SUBJECT: Safety Recall 16S26 – Supplement #9
Certain 2005-2006 Ford GT, 2005-2011 Mustang, 2006-2011 Fusion and Milan,
2006 Zephyr, 2007-2011 MKZ, 2007-2010 Edge and MKX, and 2007-2011 Ranger
Vehicles
Passenger Airbag Inflator Replacement

New! REASON FOR THIS SUPPLEMENT

- *Passenger airbag module part numbers for 2010-11 Fusion, Milan, and MKZ vehicles have changed. Previous part numbers, AE5Z-54044A74-C and AH6Z-54044A74-C, are subject to a stop sale and must be returned. **Do not perform any repairs using these part numbers.***

FIGURE 6

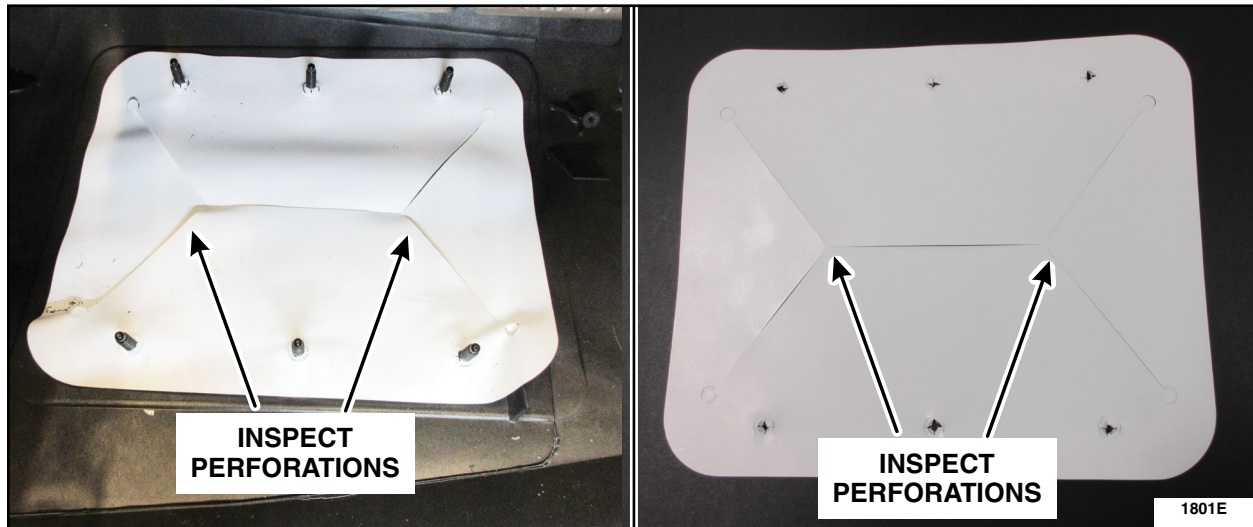
6. Inspect the white airbag cushion sheet installed on the instrument panel and the new airbag cushion sheet included with the new airbag module. See Figure 6.

NOTE: If any damage is present on the existing or new airbag cushion sheet it must be replaced. Type of damage includes, but is not limited to, cuts, creases, folds, or the perforations being broken.

7. If no damage is found, clear both sheets of any dirt or debris and **install both sheets** on the airbag mounting bracket studs. See Figure 7.

FIGURE 7

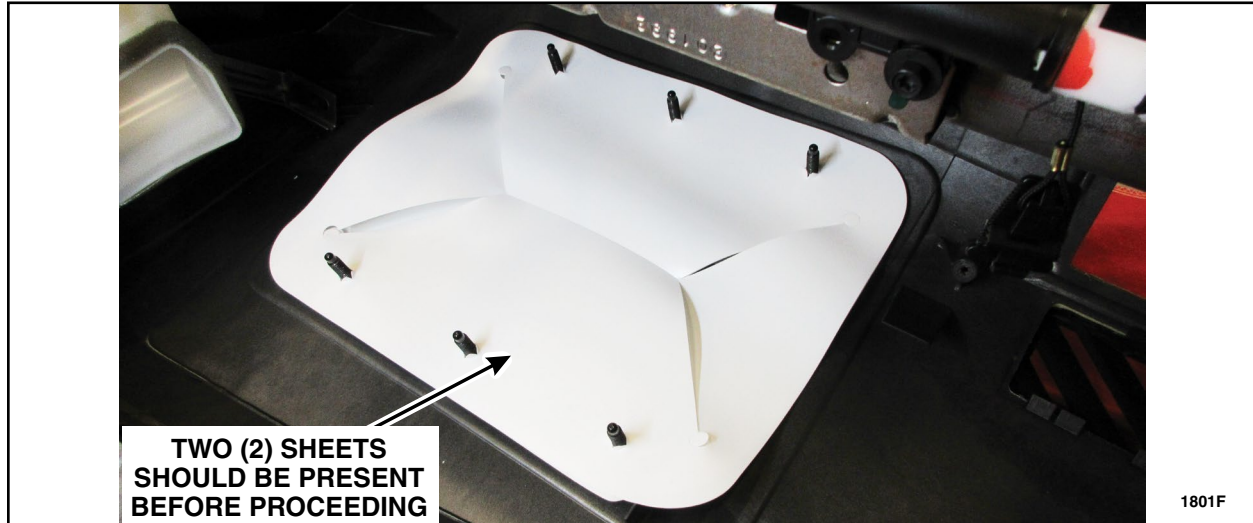
NOTE: The sheets will not lay perfectly flat when installed on the instrument panel.
